FINAL DRAINAGE REPORT FOR WATERVIEW NORTH  
PRE-SUBDIVISION GRADING

# Waterview North El Paso County, CO

Prepared: June 15, 2021  
Resubmitted: December 17, 2021

PCD FILE NO. EGP-21-004

### GVF Output Data

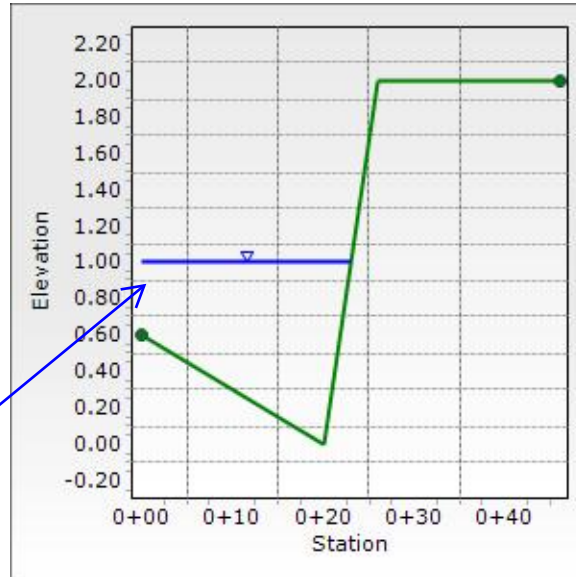
Update channel section shown to show runoff is contained entirely with irregular channel cross section.

PROJECT: WATERVIEW NORTH  
 SHEET TITLE: PRE-DEVELOPMENT BASIN MAP  
 FROM: n/a TO: n/a  
 JOB NO.: 02-19-05 SHEET 2 OF 3

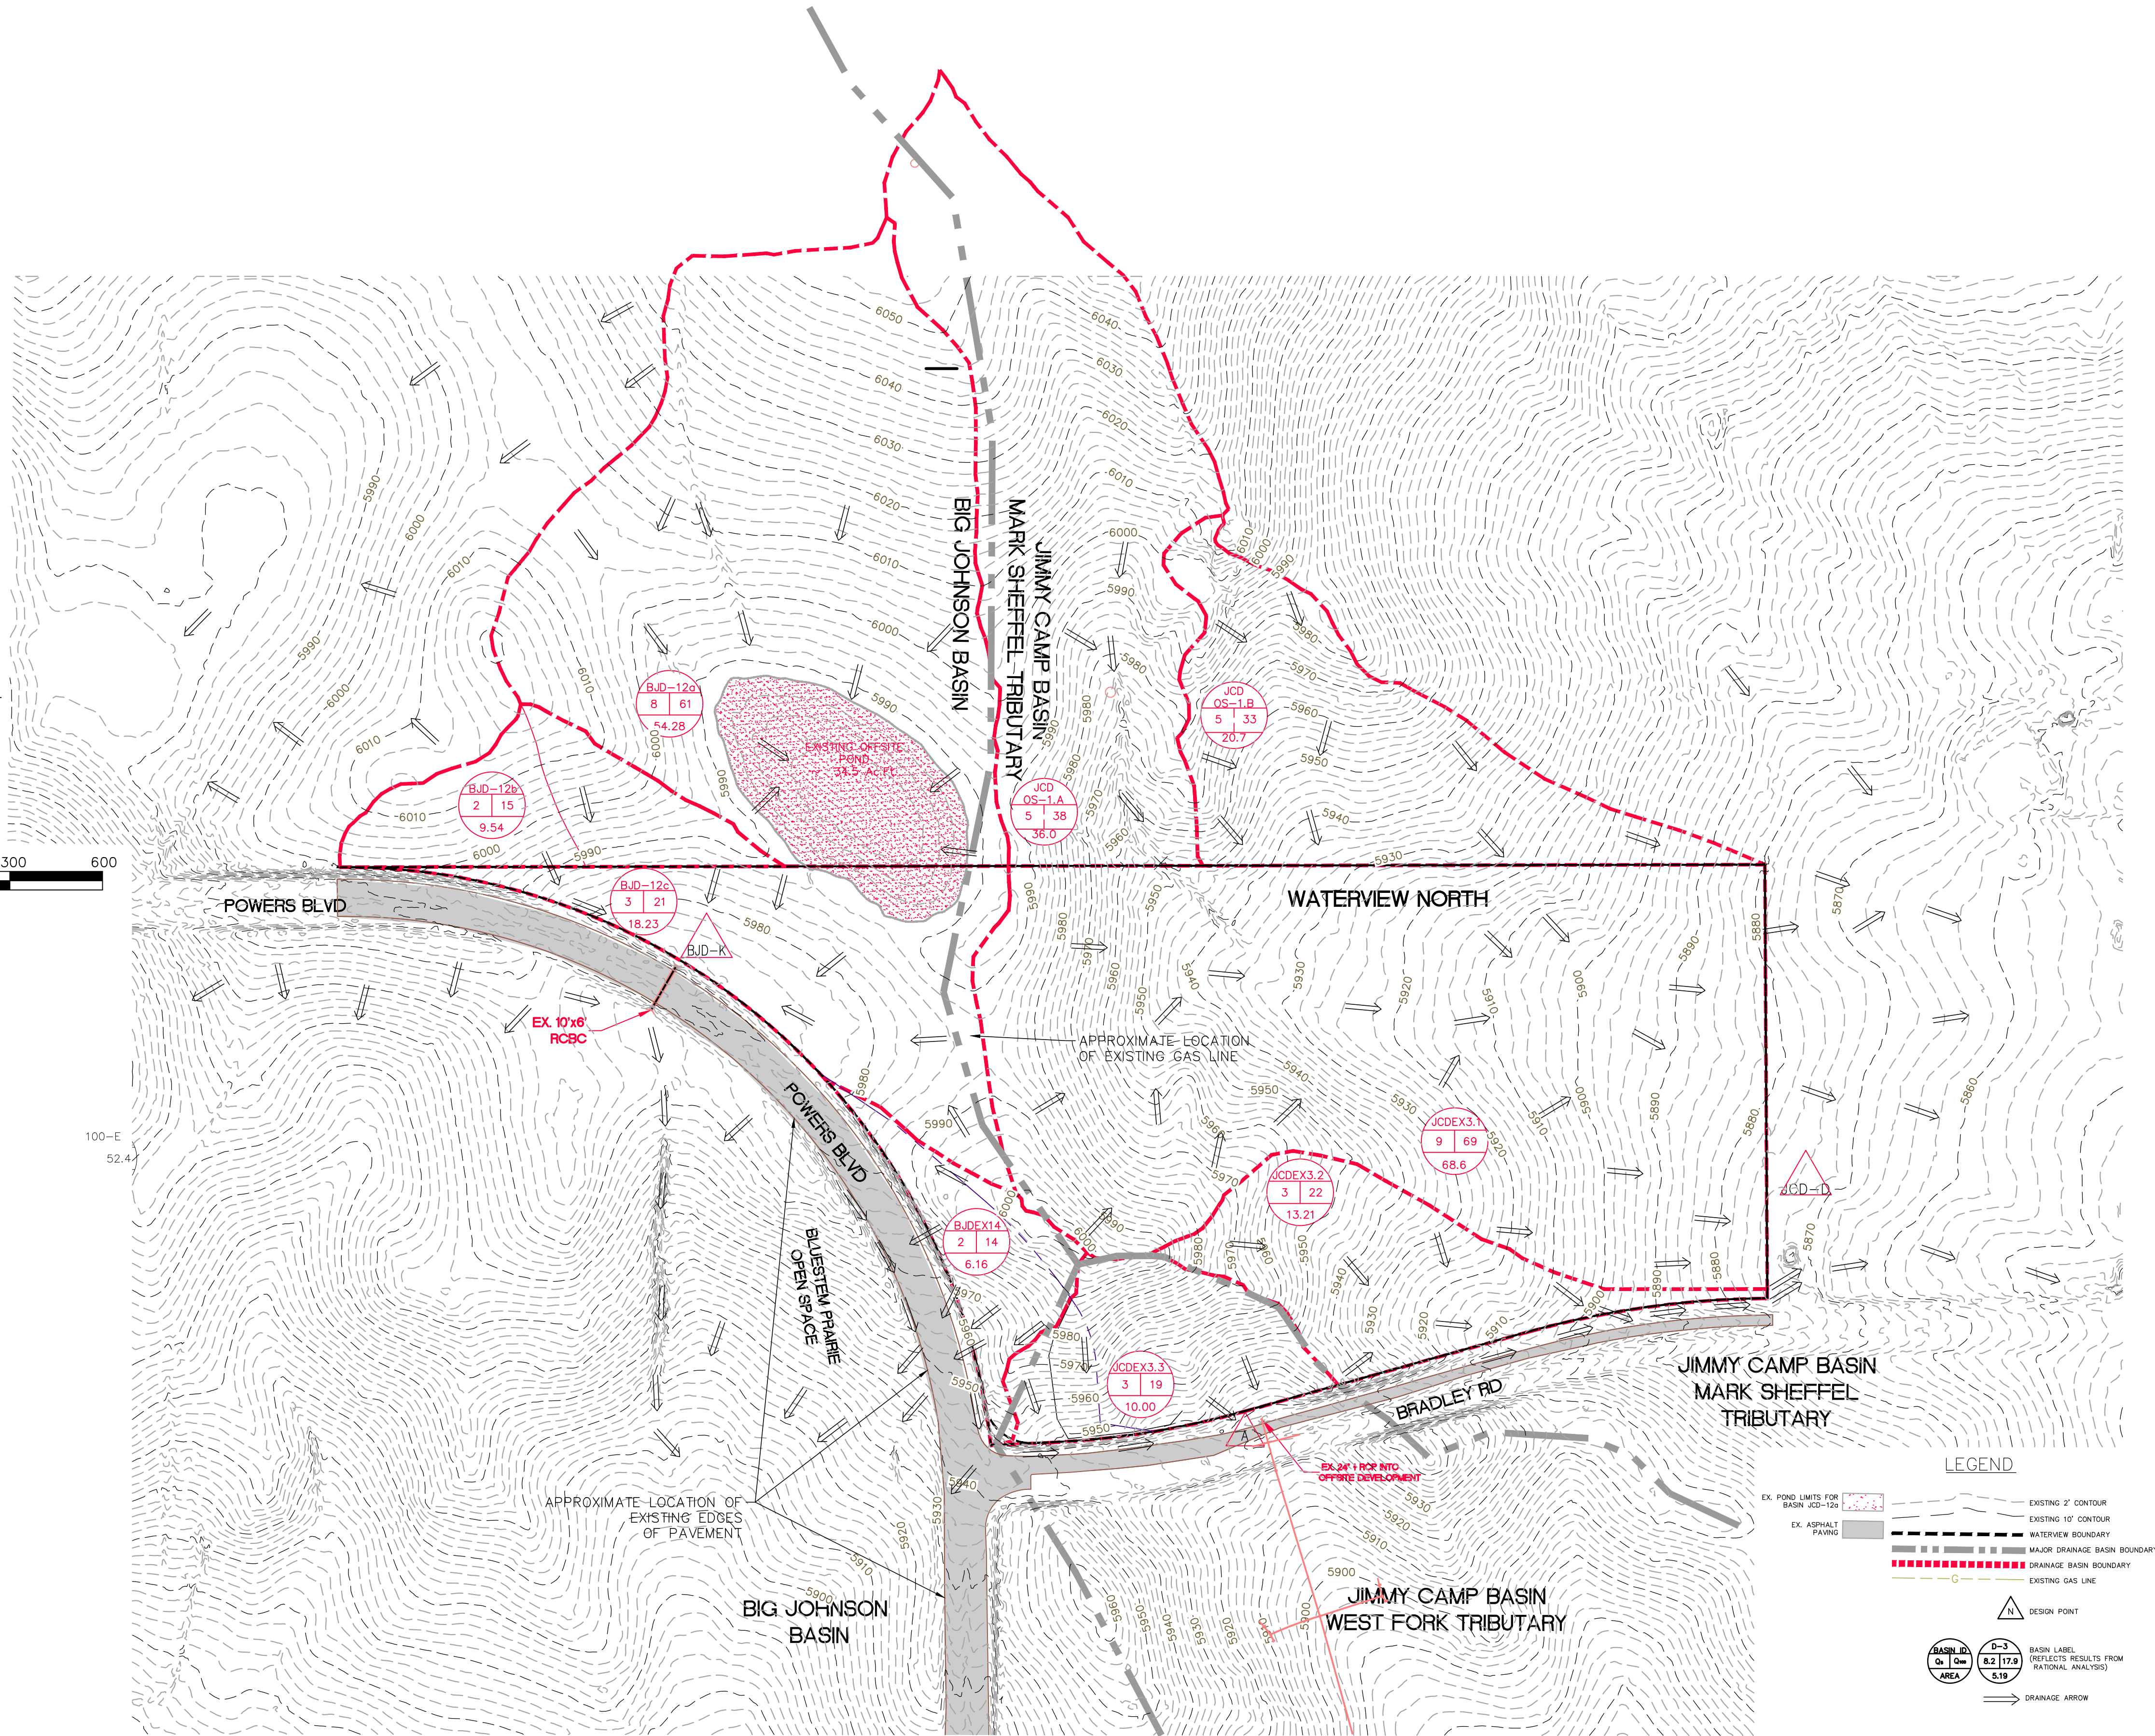
Does not correspond to basins labeled north of site on Pre-development Map

Revise the statement. This is not the historical path of the offsite basins. Historically, offsite flow drains across project site. Developed map shows swale within property boundary, along north and east property lines, keeping offsite flows on the site area.

DRAINAGE EXHIBIT – WATERVIEW NORTH COLORADO SPRINGS, CO

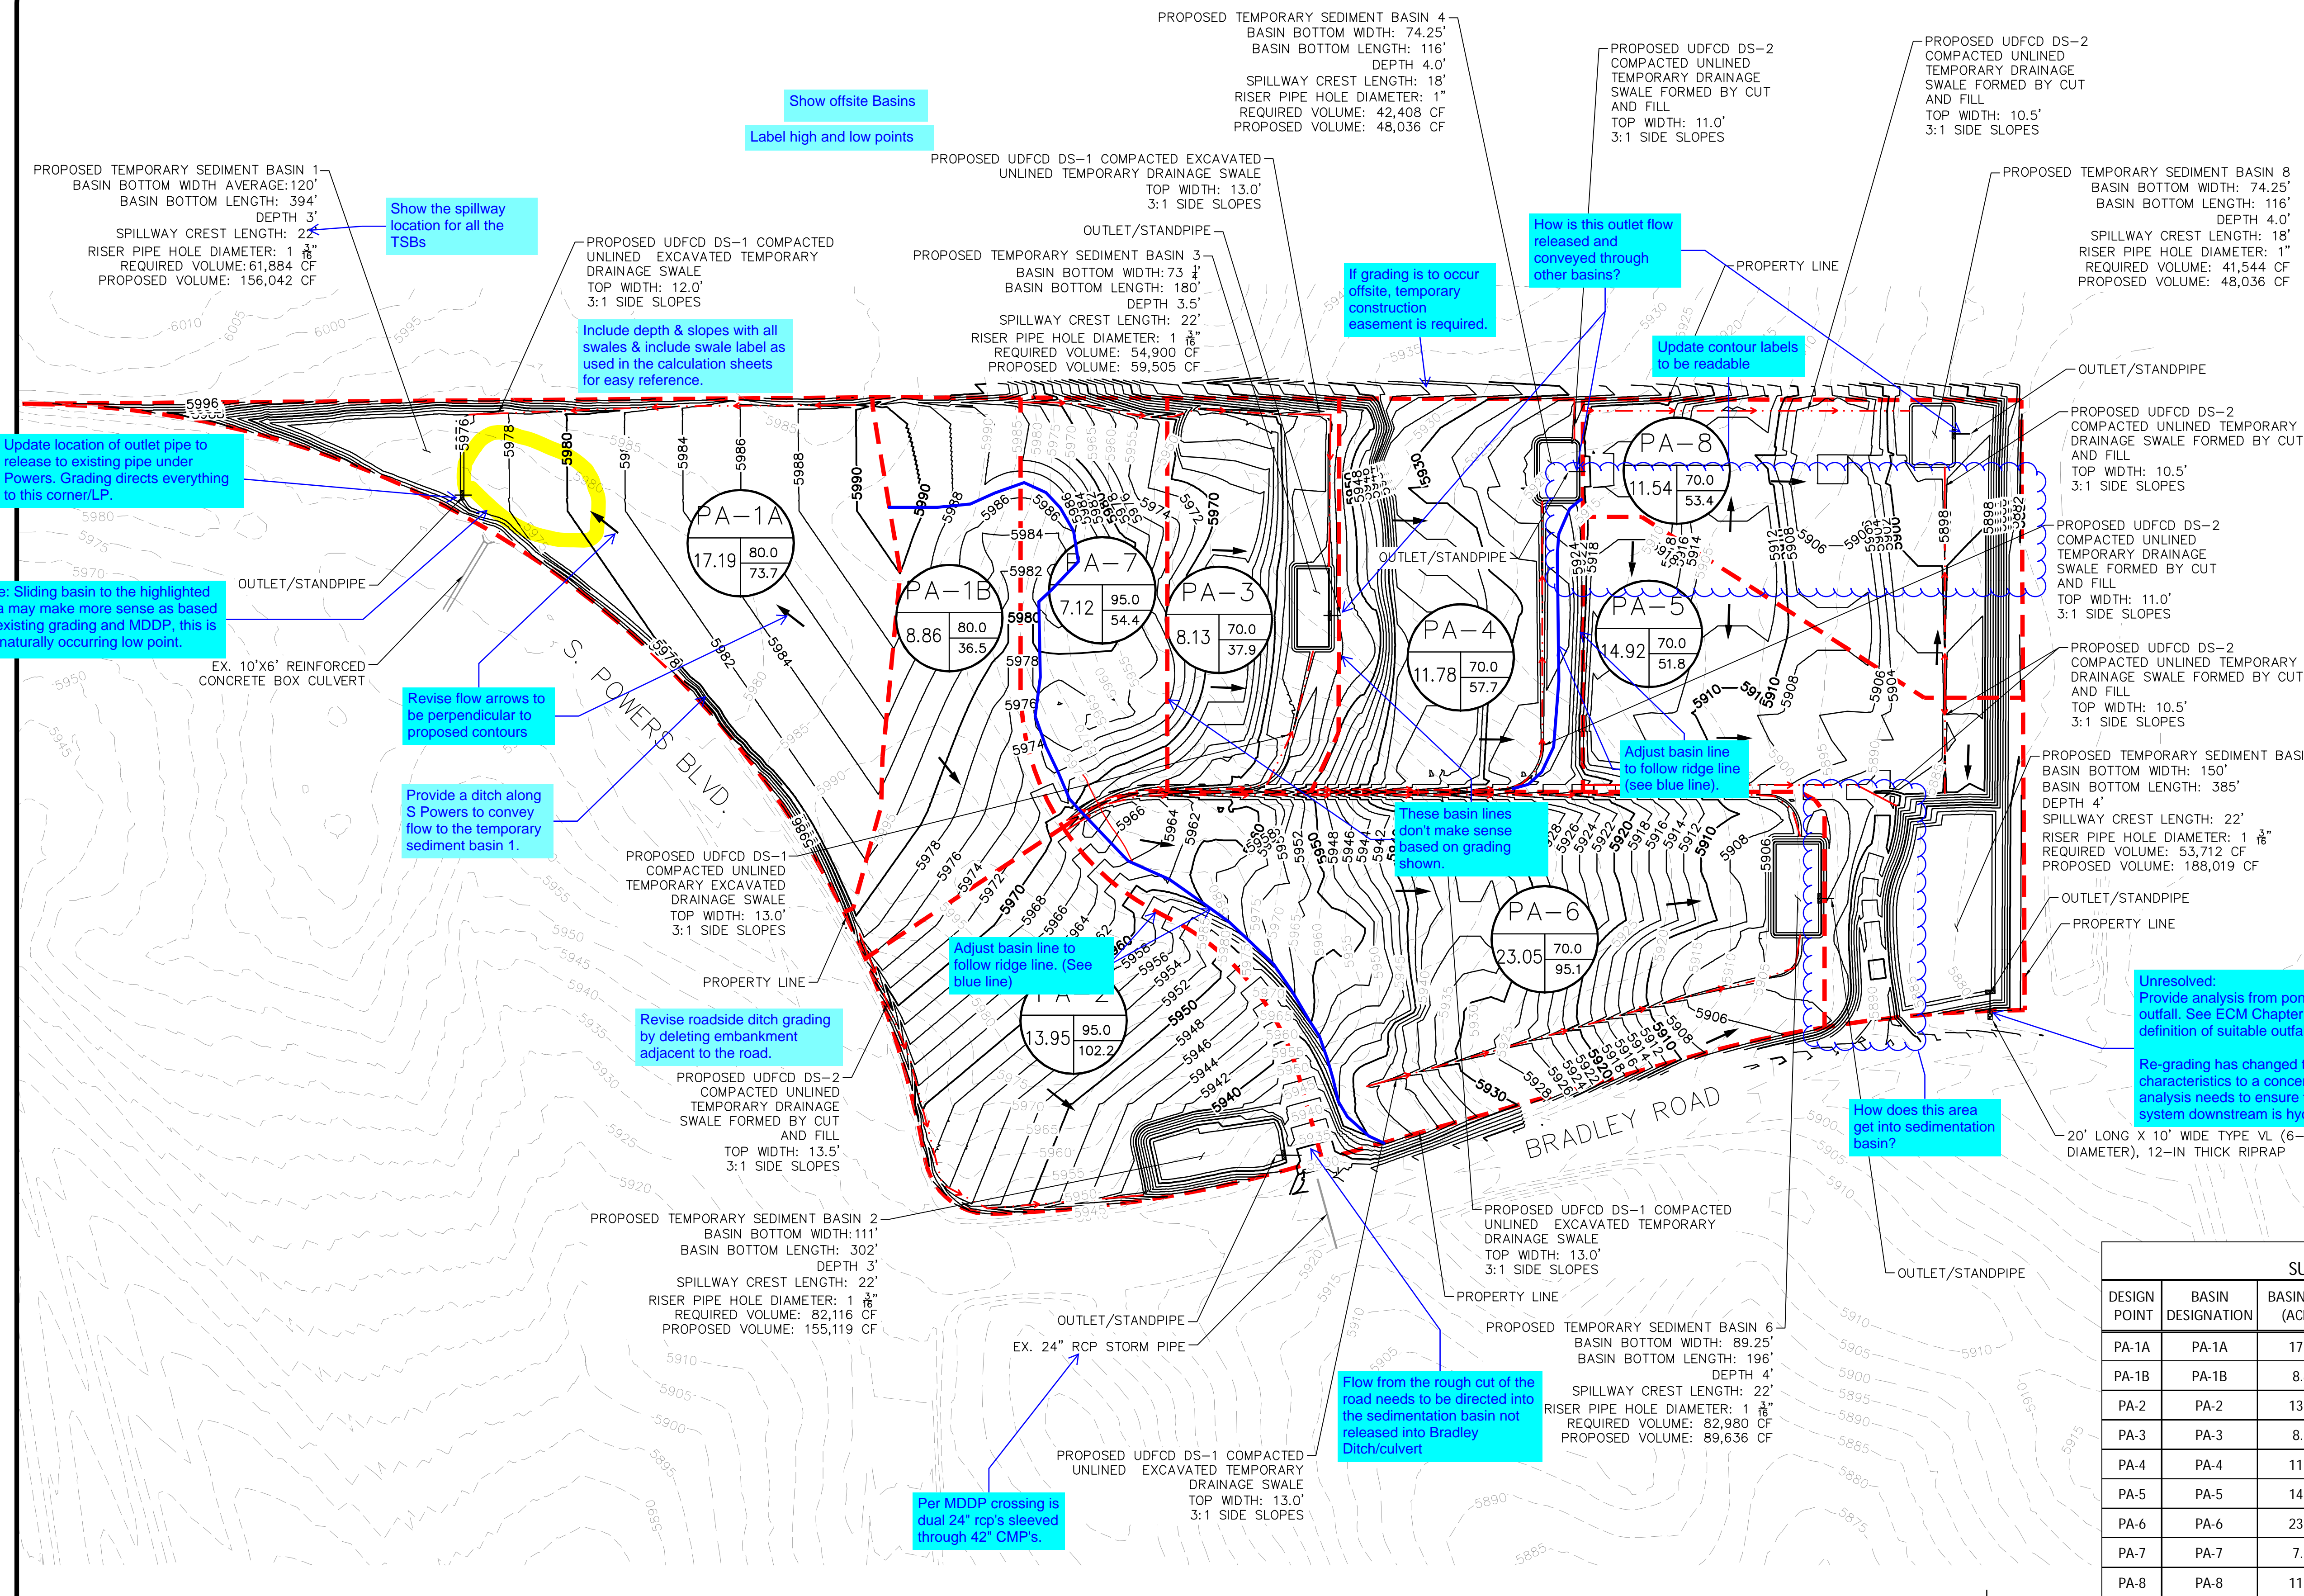
Basin area & flows do not match hydrology spreadsheet
